Cylinder Head Bolt Torque – 135 thru 220

Mariner and Mercury
Cylinder Head Bolt Torque

Figure 1. Current Style Cylinder Block

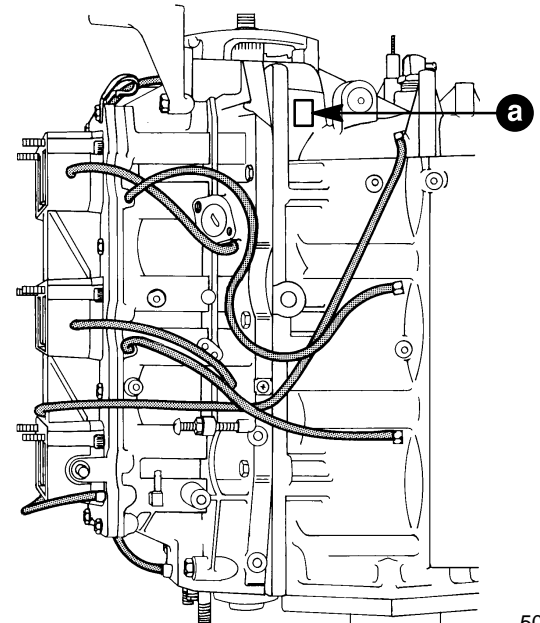
The cylinder head bolt torque has been changed on ALL the models listed that have the bolts fastened to the outside of the cylinder block. Retorque of the head bolts has been eliminated when using this new specification. The new torque specification is 30 Ft. Lbs. (40.7 N·m) plus an additional 90° turn. Figure 1 identifies the cylinder blocks that require the new head bolt torque specification.

1st – Torque all bolts to:
10 Ft. Lbs. (13.6 N·m)

2nd – Torque All Bolts To:
30 Ft. Lbs (40.7 N·m)

3rd – Turn All Bolts:
an additional 90° angle

IMPORTANT: DO NOT retorque the head bolts when using this new specification. The clamping force can not be improved by retorquing and the life of the bolt will be shortened.

Figure 2. Port side

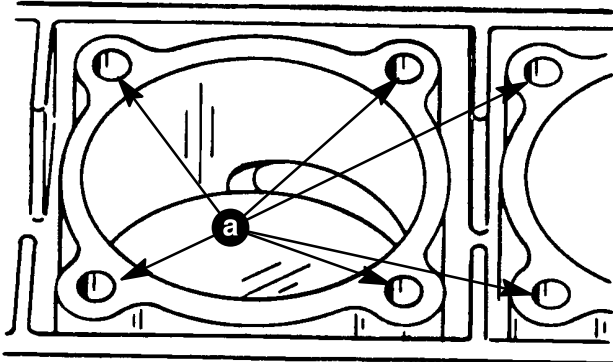
Service replacement powerheads produced since 1/14/93 have the cylinder head bolts torqued to the new specification and do not require a retorque. The date (month, day, and year) is stamped on the upper port side of the cylinder block aft of the crankcase split line (Figure 2).

Figure 3. Previous Style Cylinder Block

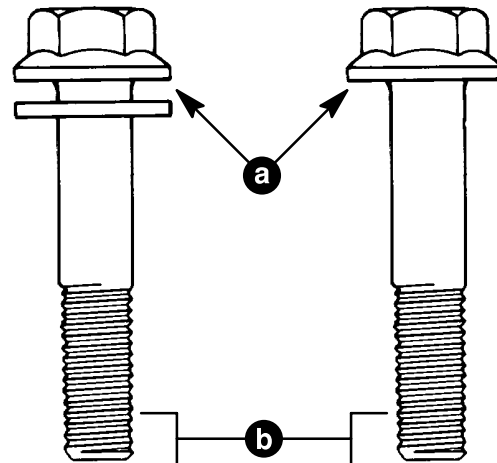
Cylinder head bolts that fasten on the cylinder liner (Figure 3) must continue to be torqued to 30 Ft. Lbs (40.7 N·m) specification. DO NOT turn the bolt an additional 90 degrees. If more torque is applied the cylinder bore may be distorted and a piston failure could occur.

1st – Torque all bolts to:
10 Ft. Lbs. (13.6 N·m)

2nd – Torque All Bolts To:
20 Ft. Lbs.(27.1 N·m)

3rd – Turn All Bolts To:
30 Ft. Lbs. (40.7 N·m)

It is necessary to retorque the cylinder head bolts on the previous style blocks after the outboard has been run the first time.

Warm the block completely by running the outboard 1/2 to 1 hour. Allow the block to cool for 2 hours. Retorque the cylinder head bolts when the engine is cold. Follow the torque sequence and do one bolt at a time. Loosen the bolt 1/4 turn and retorque it to 30 Ft. Lbs. (40.7 N·m).
